SUBJECT: Vehicle Safety Recall - SC0304
Brake Cam Lube – Steer Axle

VEHICLE RECALL

SC304

Subject: Front Axle Brake Cam Lubrication — CXN and CHN Model Chassis

Figure 2 — Inspect Brake Cam

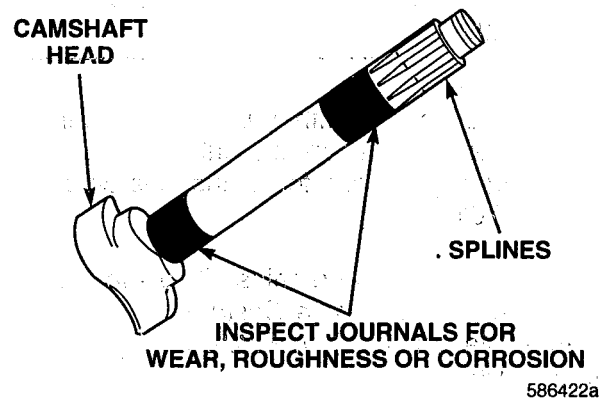
The front steer axle brake cams on all affected chassis must be removed and inspected. Inspect the area of the cam journals for wear, roughness or corrosion.

Damaged brake cams and associated brake components must be replaced per the following criteria:

- If there is no wear, roughness or corrosion evident on the brake cam journals, reinstall the cams, but replace the cam bushings and seals and brake shoe retaining hardware with new components.
- If the brake cam journals are worn, rough or corroded, replace the cam, cam bushings, seals and brake shoe retaining hardware.
